## CITY of NOVI CITY COUNCIL

Agenda Item E  
May 23, 2016

# JSP 15-76 Montebello Estates

Re: **Montebello Estates**  
**Novi Project Number JSP 15-76**  
**Variance Response Letter**

**OPTION 3**

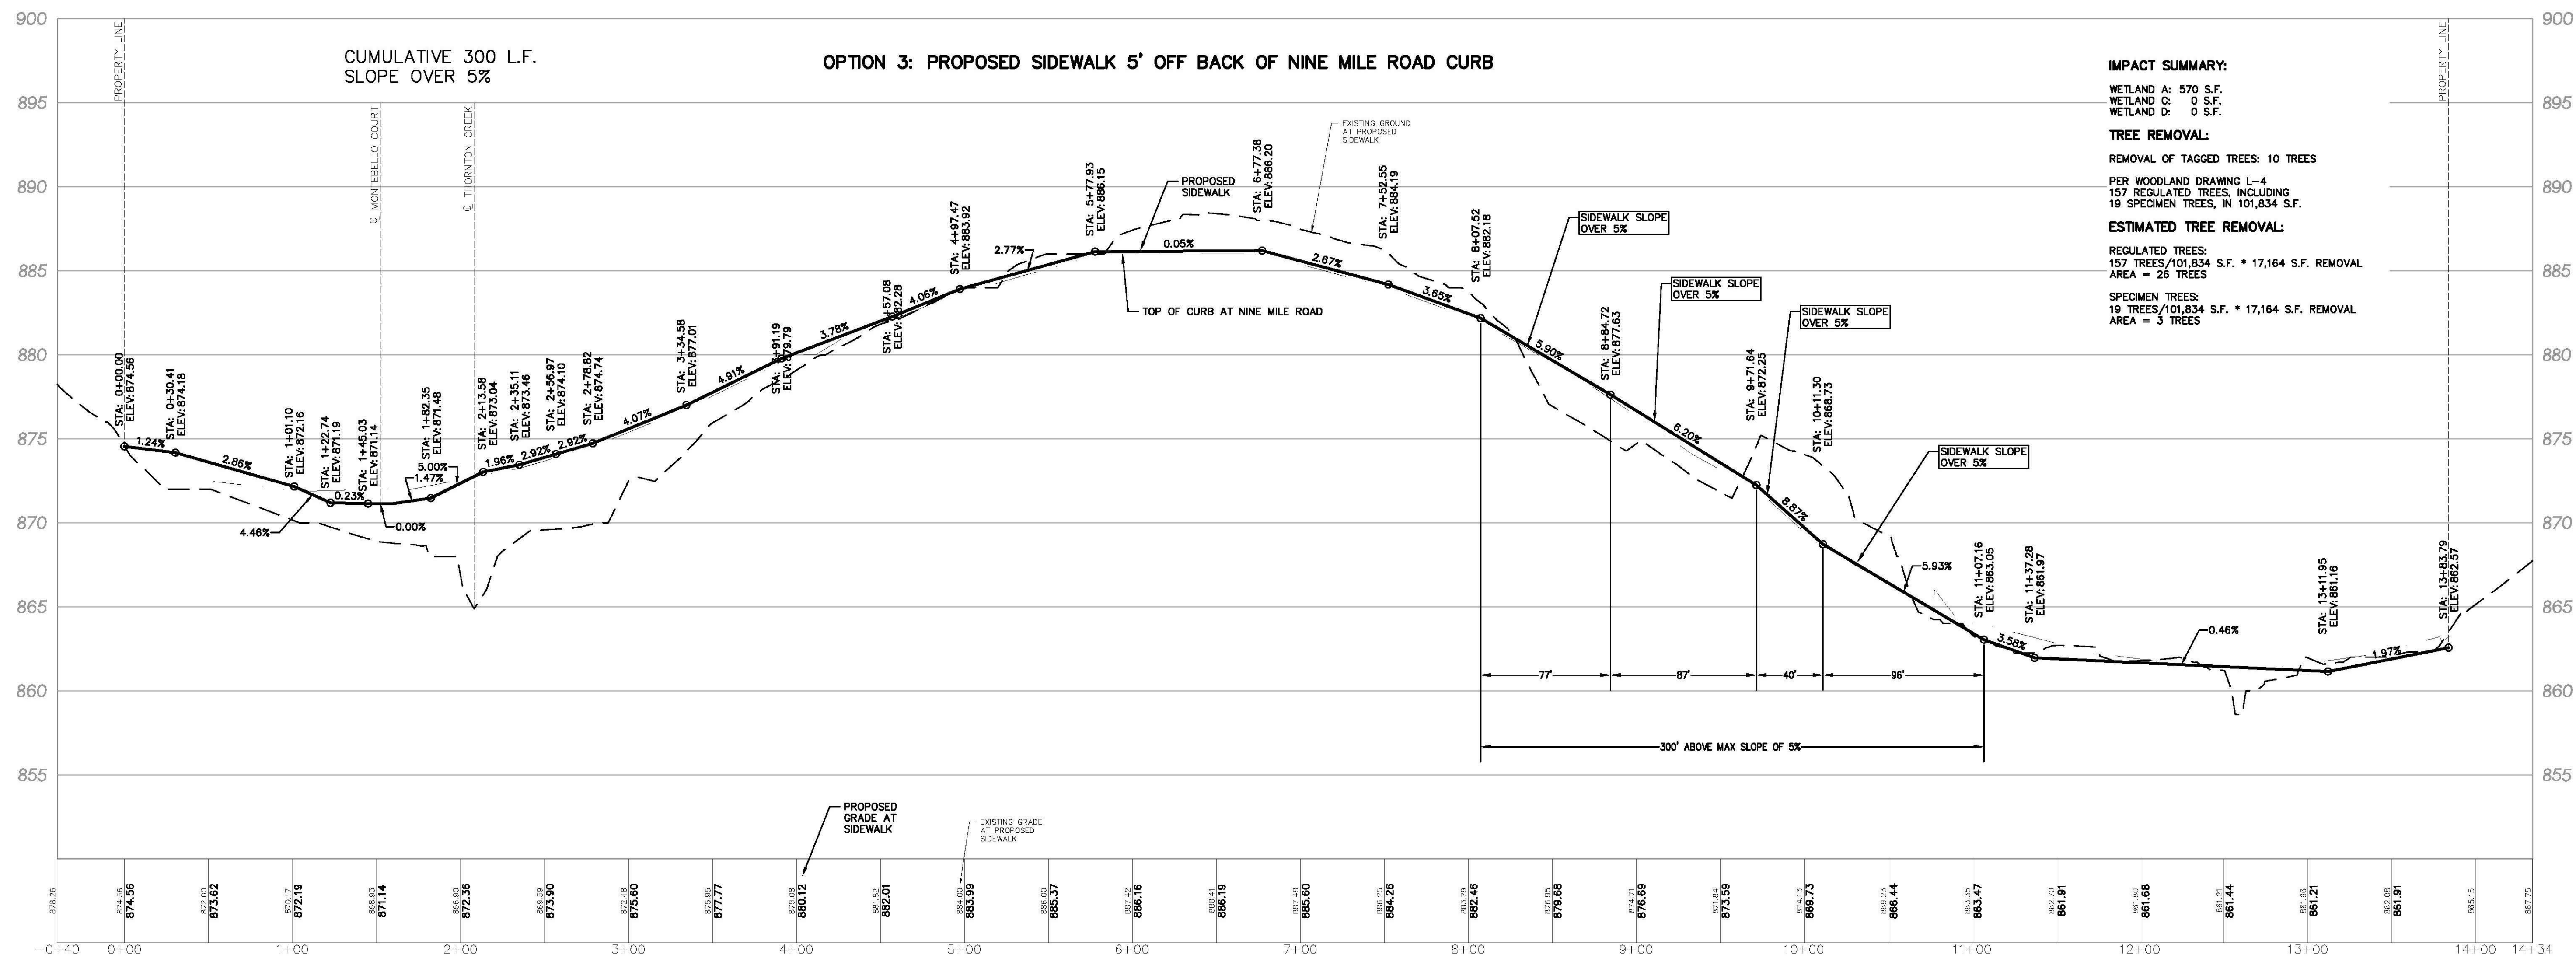
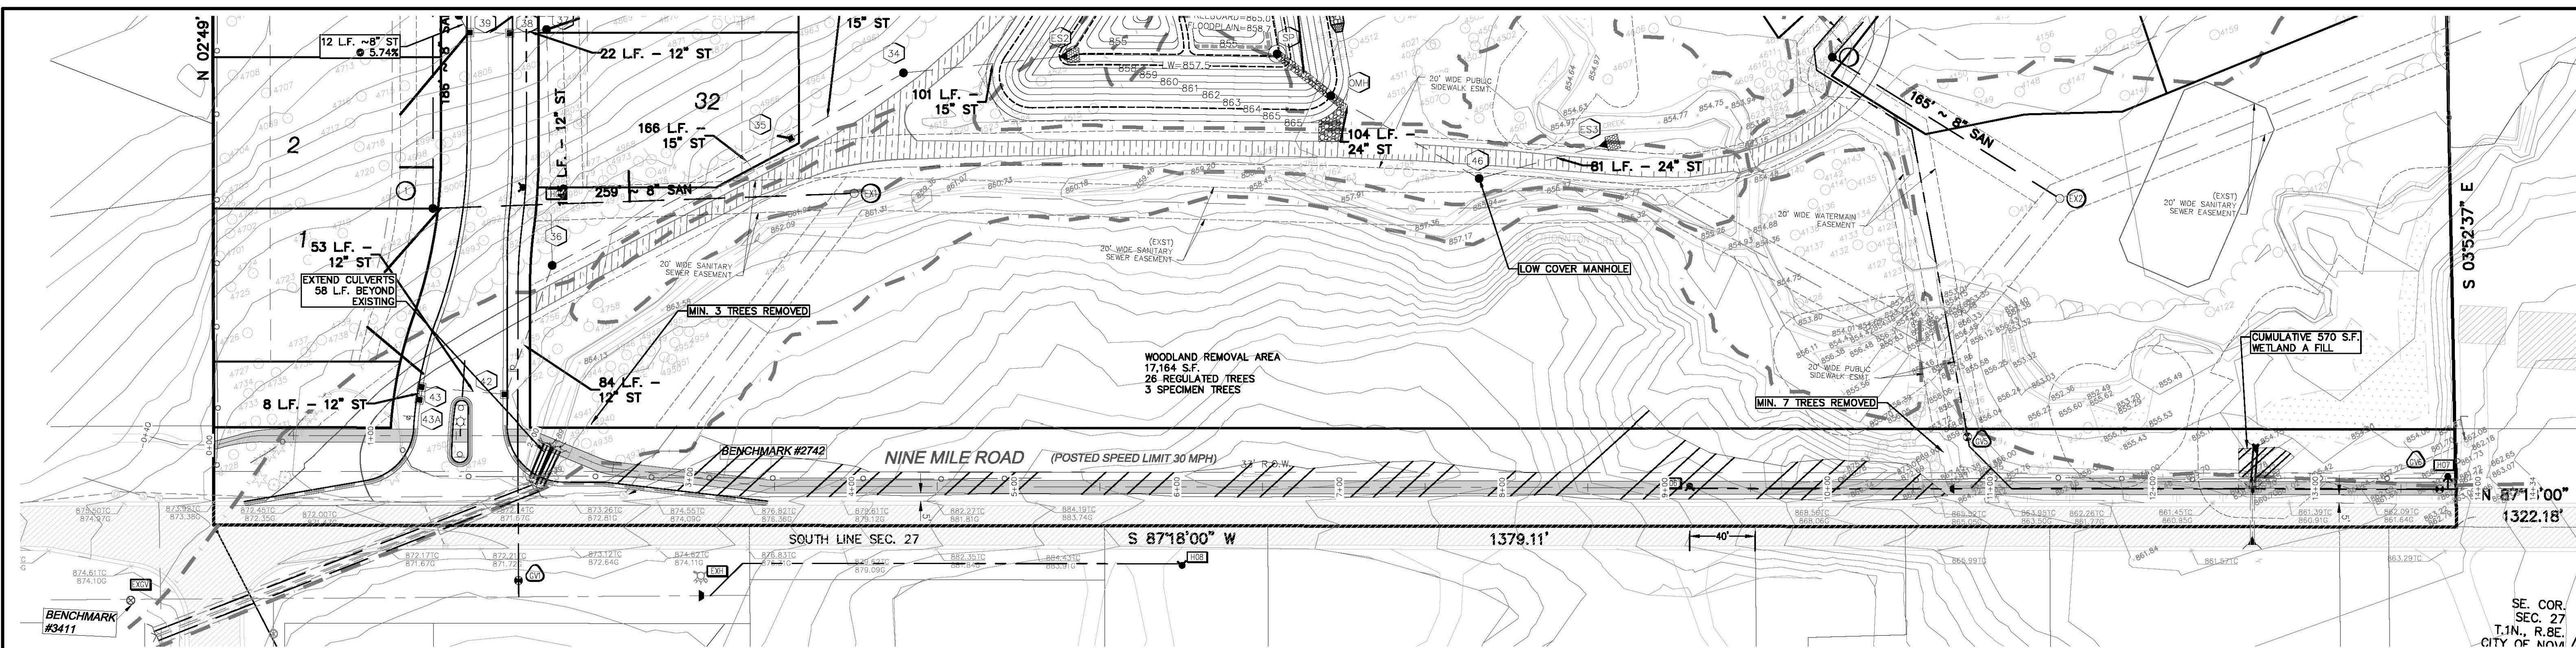
Per your request, the easterly water main has been extended westerly to provide 40-feet of water main frontage to the adjacent parcel located on the south side of Nine Mile Road.

1. The portion of the sidewalk that crosses Montebello Court on an angle has been revised to a 90-degree crossing as discussed.
2. A note has been added to sheet 1 indicating that 1-1/2" of asphalt will be milled from the walkway and a new 1-1/2" layer of asphalt overlaid on the pathway. It should be noted that this work will be provided in the case that the path would be maintained by the City of Novi. Such work would not be provided if maintained by the HOA.
